WATER QUALITY MEMORANDUM

Utah Coal Regulatory Program

RE: 2004 Second Quarter Water Monitoring, Canyon Fuel Company, LLC, Skyline Mine, C/007/0005-WQ04-2, Task ID #1946

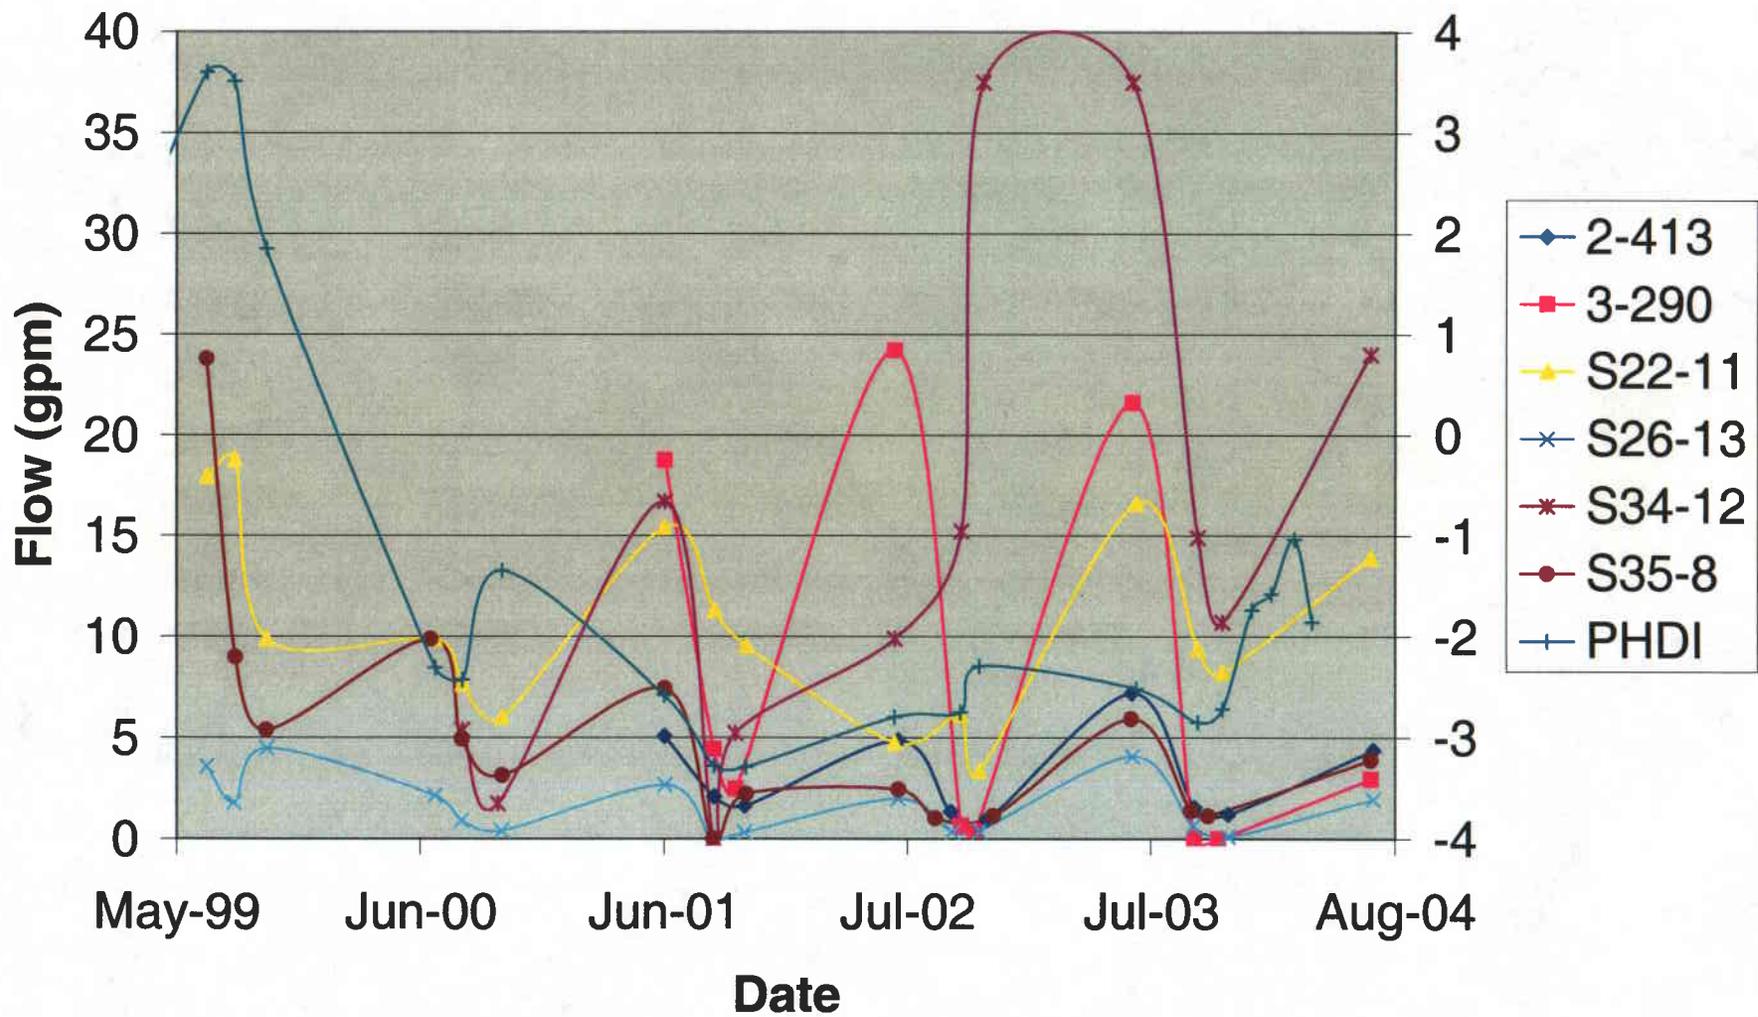
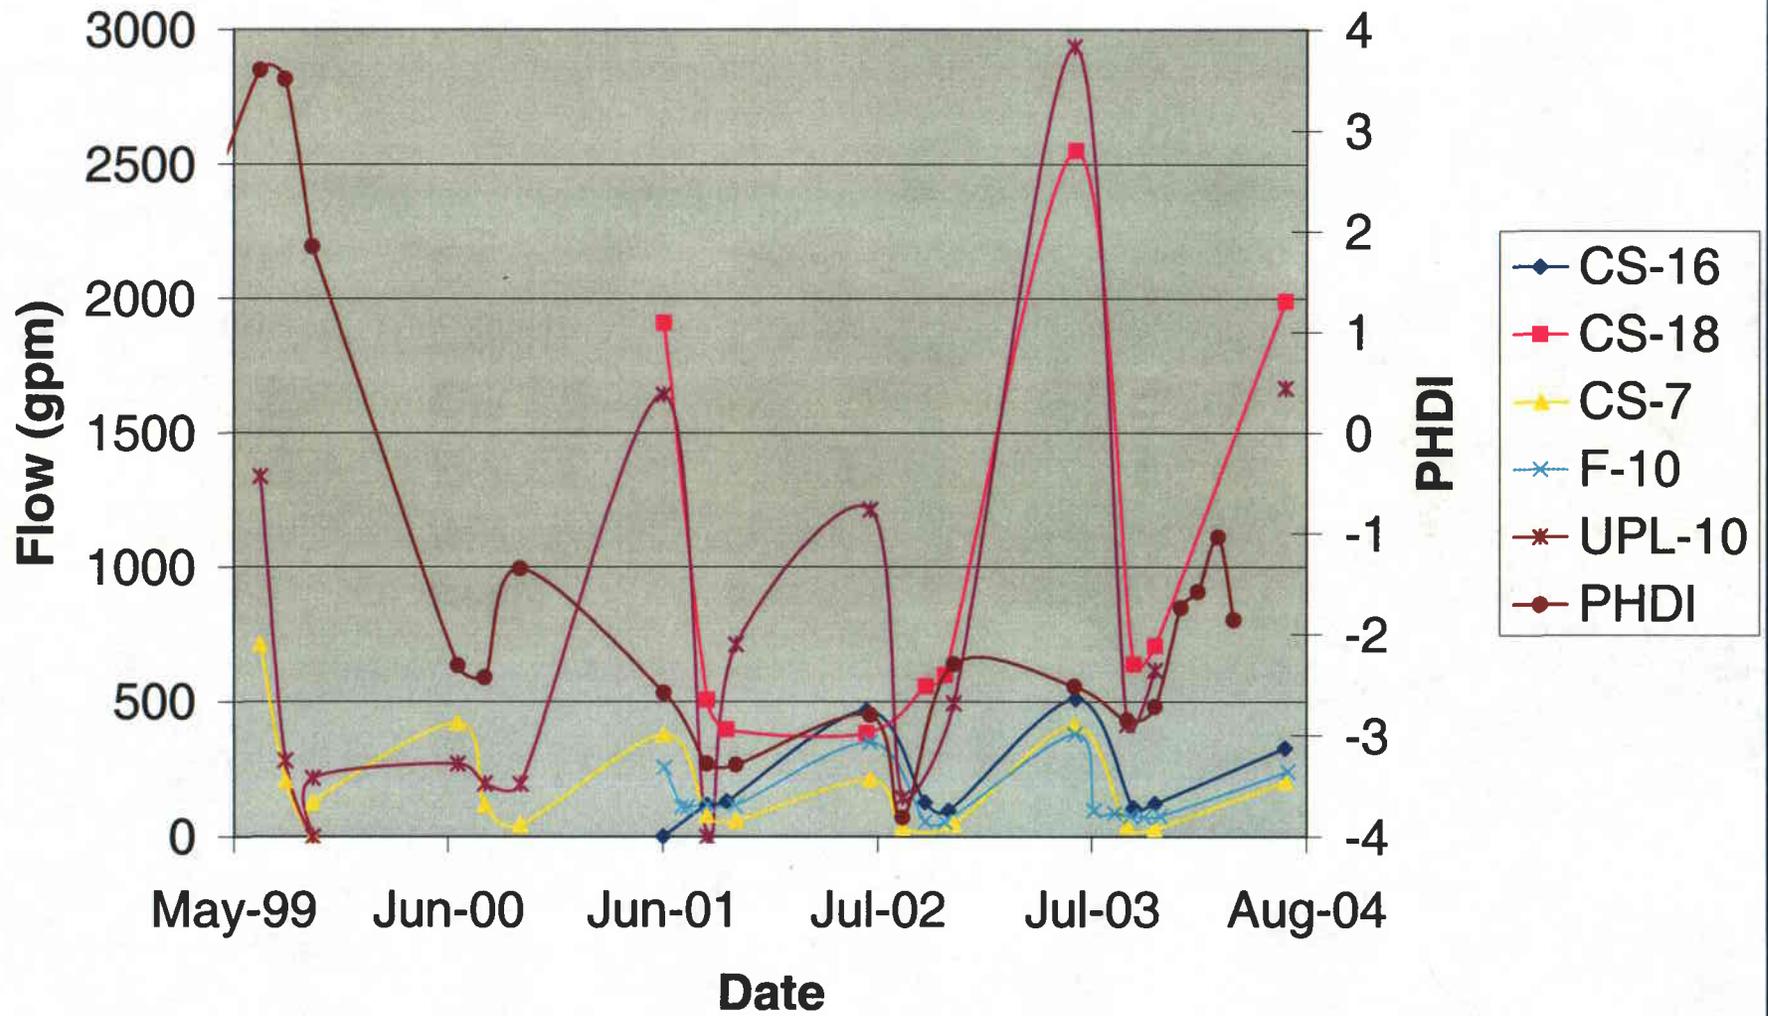
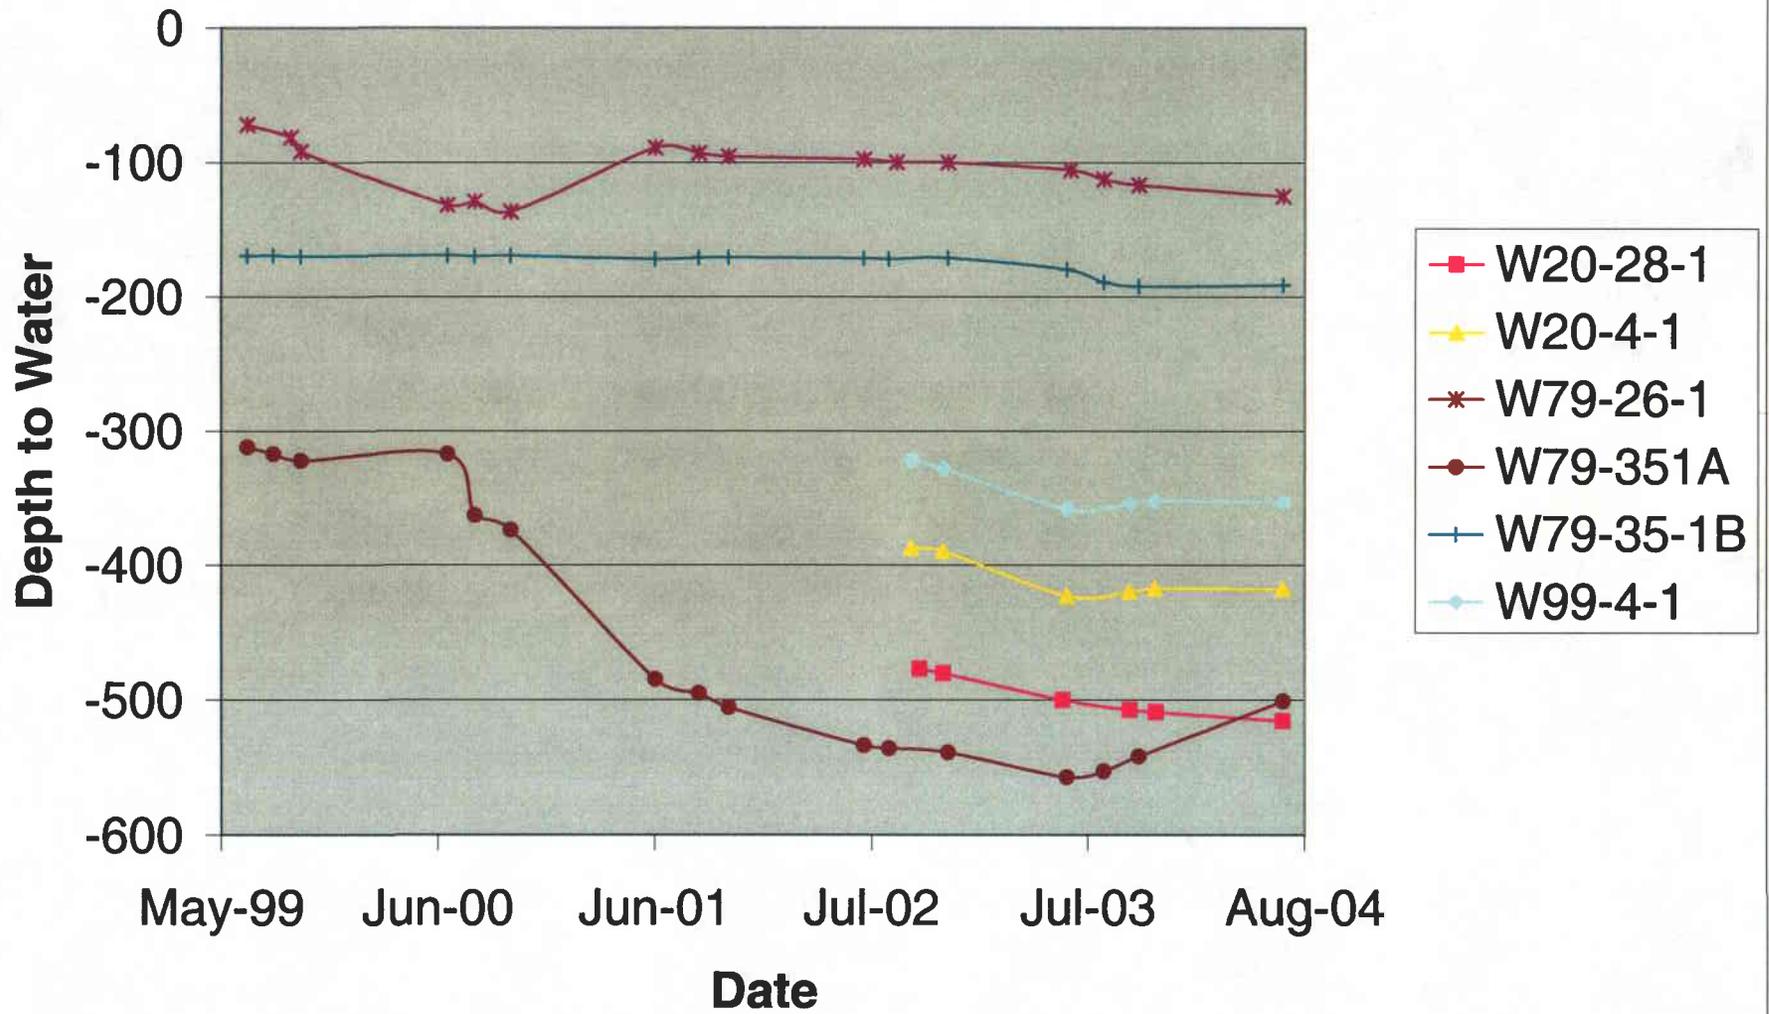
To monitor whether there is any correlation between the performance of Electric Lake and the streams, springs, and wells being monitored in the Upper Huntington Creek basin by Skyline Mine, graphs have been developed by the Division and attached to this report. The flows noted in the streams and springs do not show any significant reductions in flow that cannot be explained by the currently dry conditions observed over the last few years. It would be anticipated that if systematic draining of the Blackhawk Formation were occurring, it would be observed in the streams, springs, and Electric Lake. The wells monitored within the Starpoint Sandstone or beneath the coal seam have all shown decreases in elevations over the last few years. As the mine has been flooding many of the wells are starting to recover. These conditions will continue to be monitored in the future.
